Rezoning Transportation Analysis

Petition Number: 2021-089

General Location Identifier: 10503127

Date	Description
08-20-2021	First Review (WB)
10-15-2021	Second Review (AO)

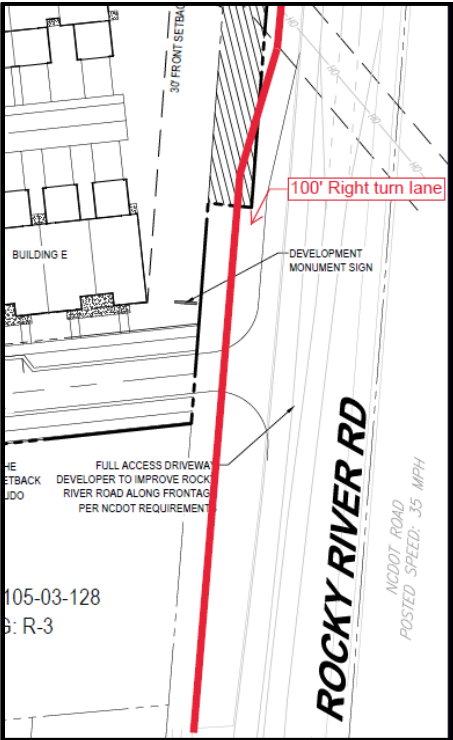
3. ~~Revise site plan and conditional note(s) to commit to dedicate 50' (minimum) right of way from the Rocky River Road centerline. The site plan shall label and dimension the right of way from the road centerline.~~

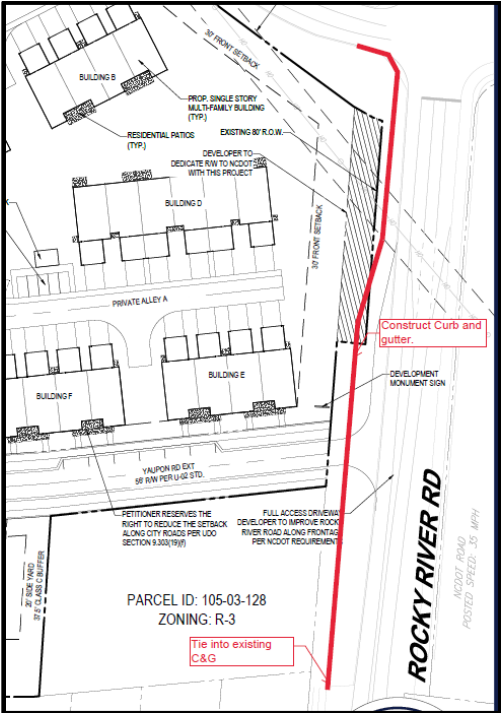
5. ~~Site plan and conditional note(s) revisions are needed to commit to providing a 100' right turn lane at the site's access on Rocky River Road per the NCDOT's standards. The proposed right turn lane should be dimensioned.~~

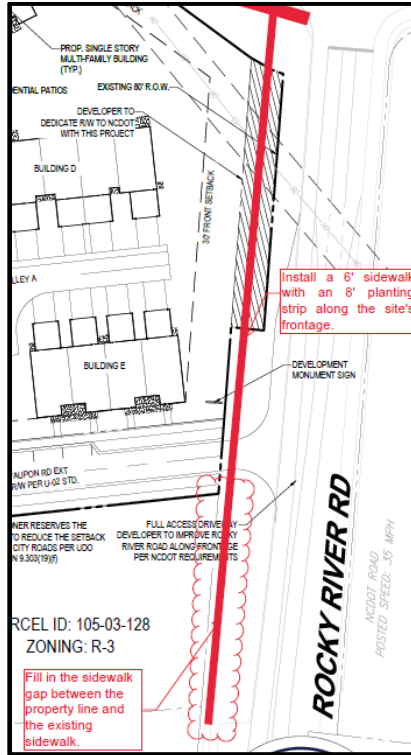
6. ~~Site plan and conditional note(s) revisions are needed to commit to construct bicycle facilities by installing the curb and gutter 35' from the Rocky River Road centerline per the Charlotte's BIKE Policy. The proposed curblines should match what has been set up west of the project.~~

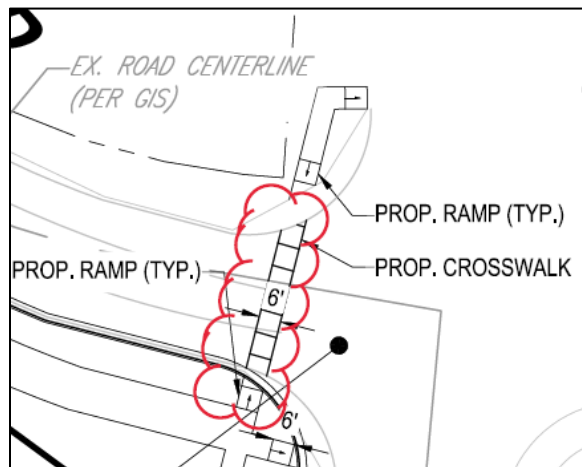
7. ~~Revise site plan and conditional note(s) to commit to construct an 8-foot planting strip, and 6-foot sidewalk on Rocky River Road per Chapter 20. Tie into the existing sidewalk west of the site to provide pedestrian connectivity and accessibility in accordance with PROWAG and the Charlotte Walks plan. The site plan shall label and dimension both items from the back of curb and gutter.~~

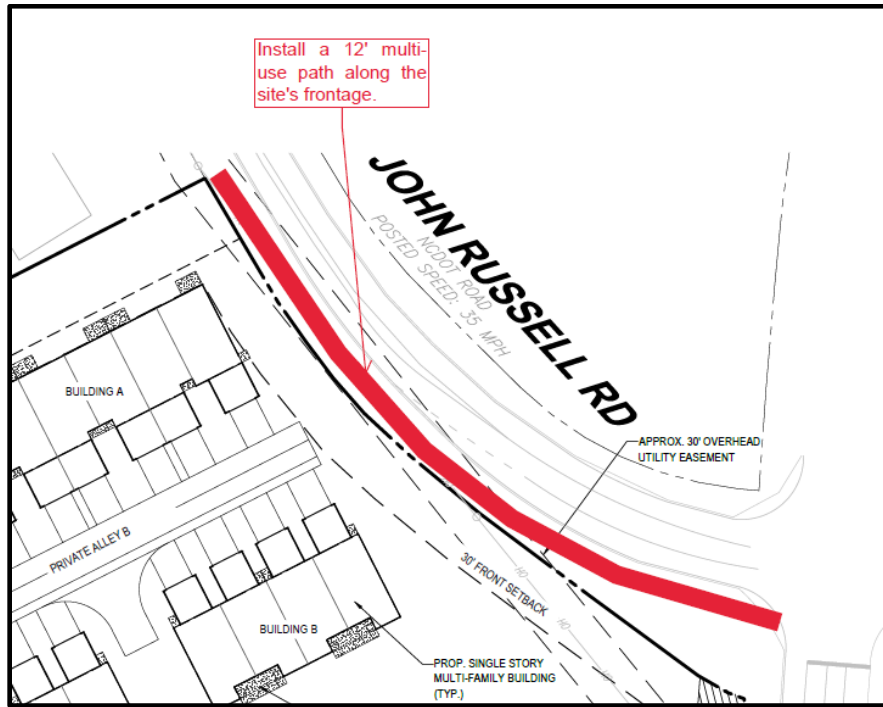
8. Revise site plan and conditional note(s) to commit to construct accessible ramps and a crosswalk at the John Russel Road Intersection to provide accessibility in accordance with PROWAG and ADA. The site plan shall label and dimension all items.

Technical Clarification (10-18-21): The crosswalk width to be 10' wide unless otherwise specified.

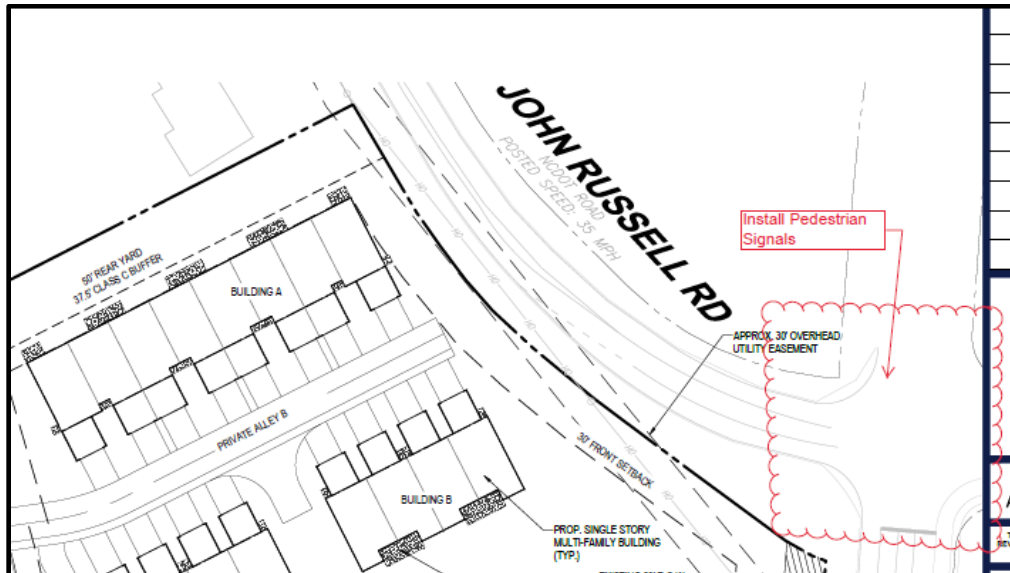
9. ~~Site plan and conditional note(s) revisions are needed to commit to construct pedestrian and bicycle facilities by installing a 12' multi-use path along the John Russel Road Frontage in accordance with the Charlotte BIKES Policy.~~

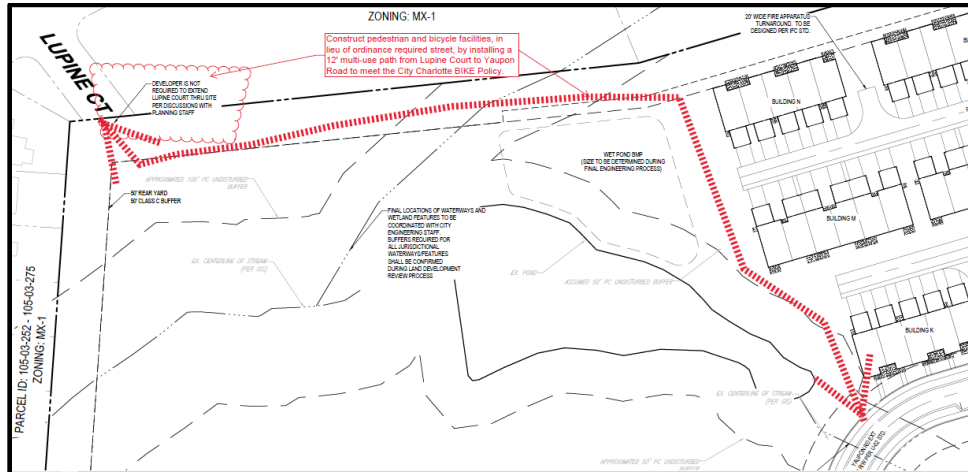
10. ~~Site plan and conditional note(s) revisions are needed to commit to upgrade the pedestrian signal equipment at the John Russel Road and Rocky River Road intersection to meet PROWAG and ADA standards. The pedestrian signal upgrade will include APS installation and the relocation of pedestrian signals off existing wood pole~~
